CLINTON CSO
STORAGE FACILITY PROJECT

CONTRACT NO. 7
BID REFERENCE NO. 7234
PROJECT NO. 587960

COUNTY OF ONONDAGA
DEPARTMENT OF WATER ENVIRONMENT PROTECTION

RECORD DRAWING

S-105

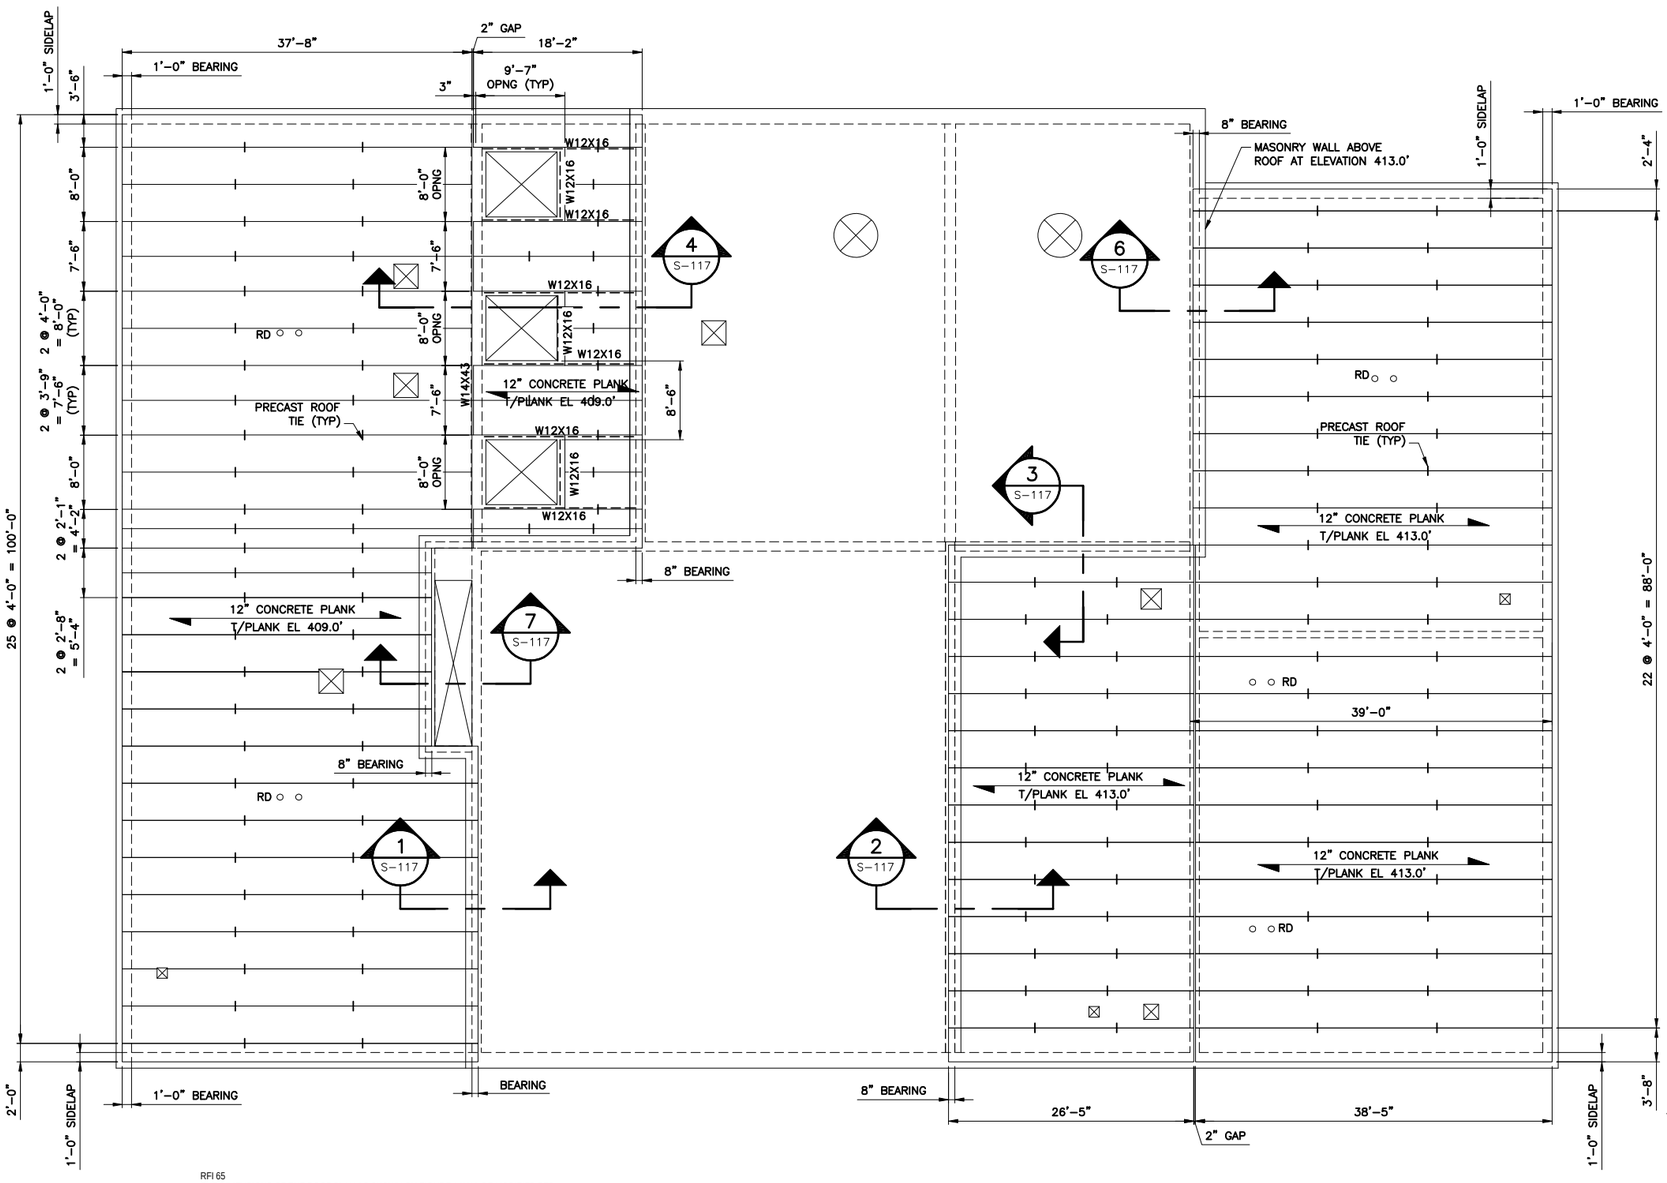
RFI 65
THE DIMENSIONS OF THE ROOF PLAN AS SHOWN ON FIGURE 1 WILL BE MODIFIED PER FIELD ORDER 9.

RFI 249
THE PROPOSED 12-INCH DEEP MASONRY LINTEL IS INADEQUATE FOR THIS 6-FOOT WIDE OPENING. REFER TO FIELD ORDER NO. 41 FOR THE REQUESTED MASONRY LINTEL DETAIL.

S-106

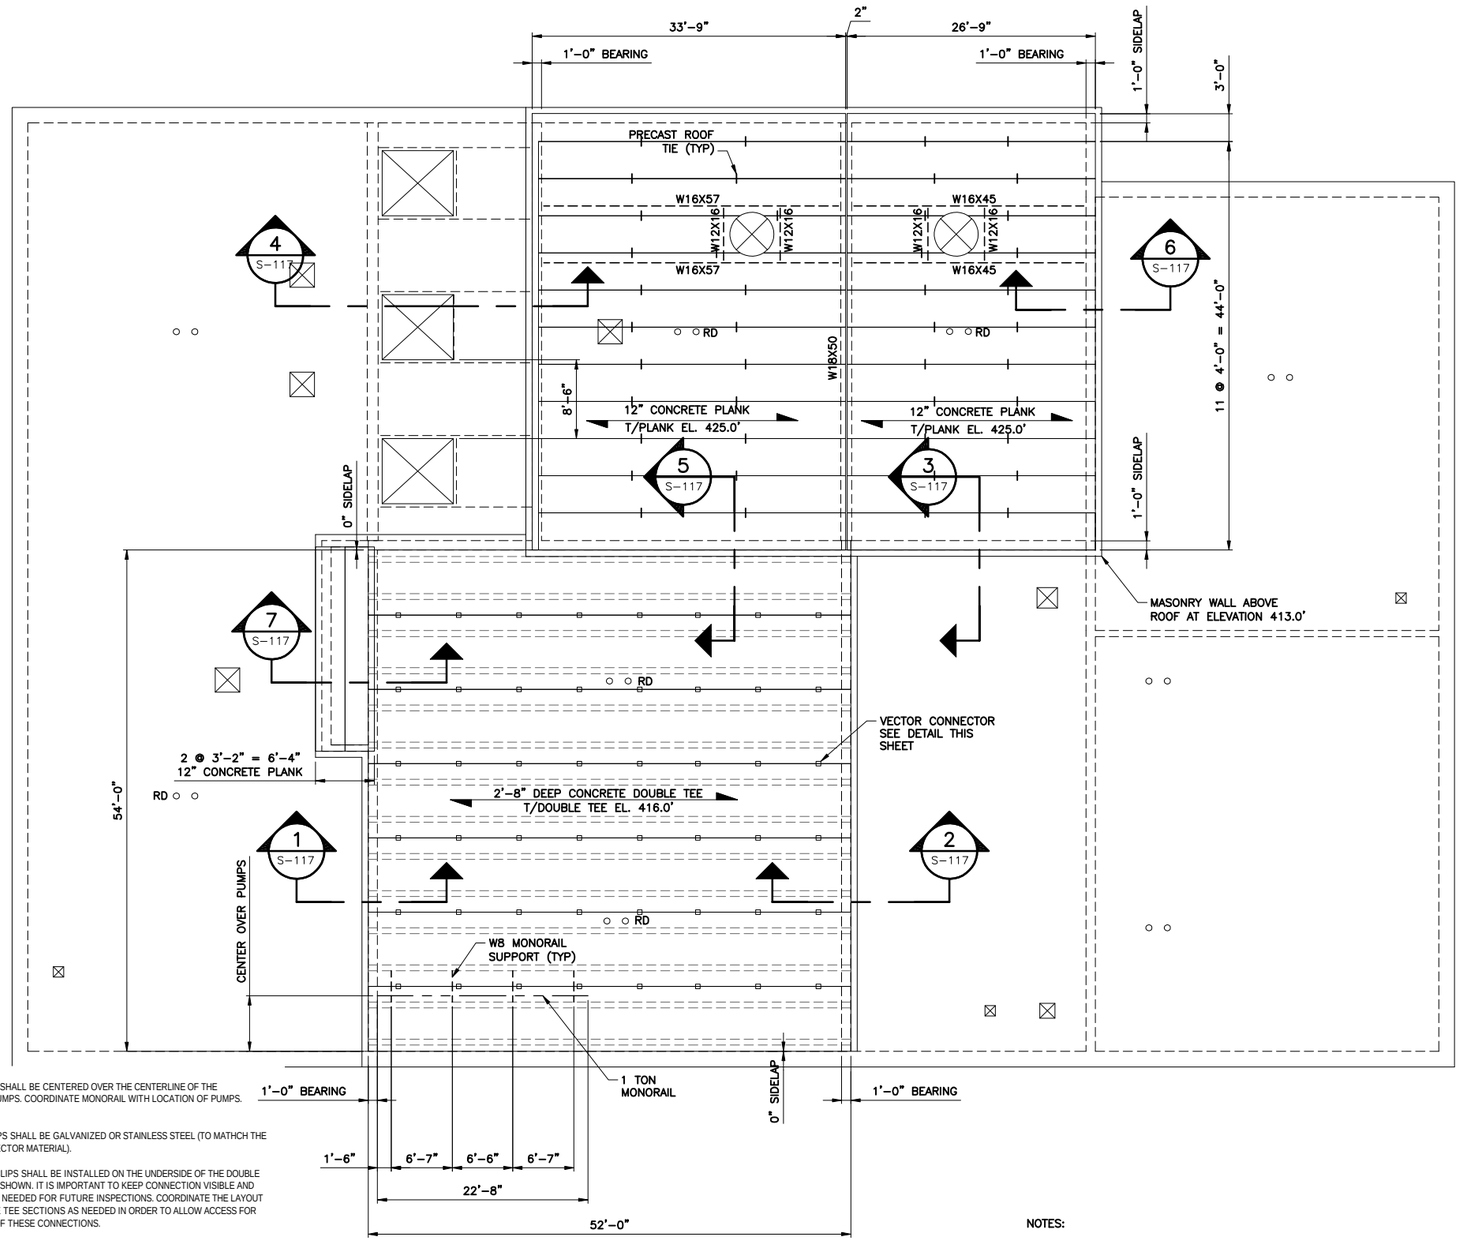
RFI 155
THE MONORAIL SHALL BE CENTERED OVER THE CENTERLINE OF THE DEWATERING PUMPS. COORDINATE MONORAIL WITH LOCATION OF PUMPS.

RFI 166
THE ANGLE CLIPS SHALL BE GALVANIZED OR STAINLESS STEEL (TO MATHCH THE VECTOR CONNECTOR MATERIAL).

RFI 238
THE CORRECT OVERALL NORTH-SOUTH DIMENSION IS 54'-0". DRAWING A-101, THE PROVIDED 5'-10" DIMENSION ALONG THE EAST WALL OF THE GRIT ROOM SHOULD BE REVISED TO 6'-10". THE OVERALL 56'-0" DIMENSION PROVIDED ON CONTRACT DRAWING S-107 SHOULD BE REVISED TO 54'-0".

S-112

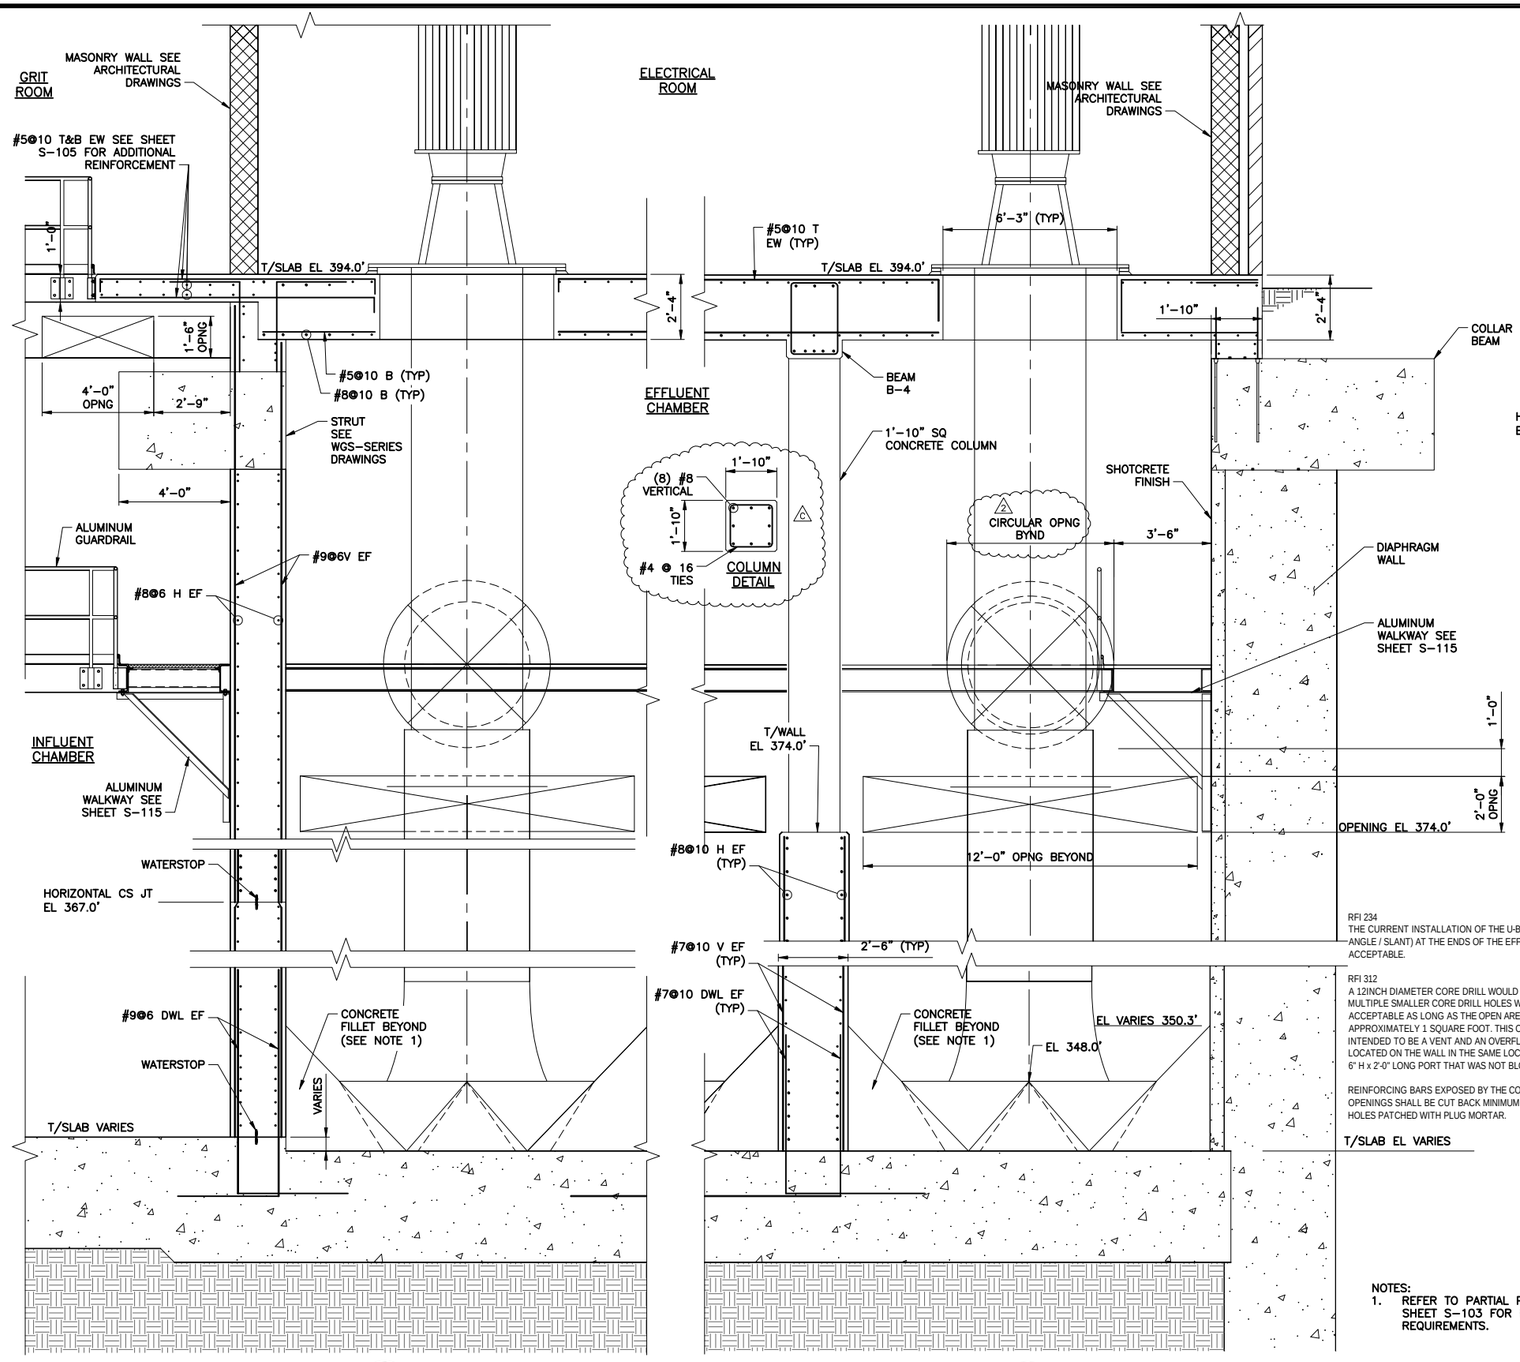
RFI 234
THE CURRENT INSTALLATION OF THE U-BARS (PLACE ON AN ANGLE / SLANT) AT THE ENDS OF THE EFFLUENT WALLS IS ACCEPTABLE.
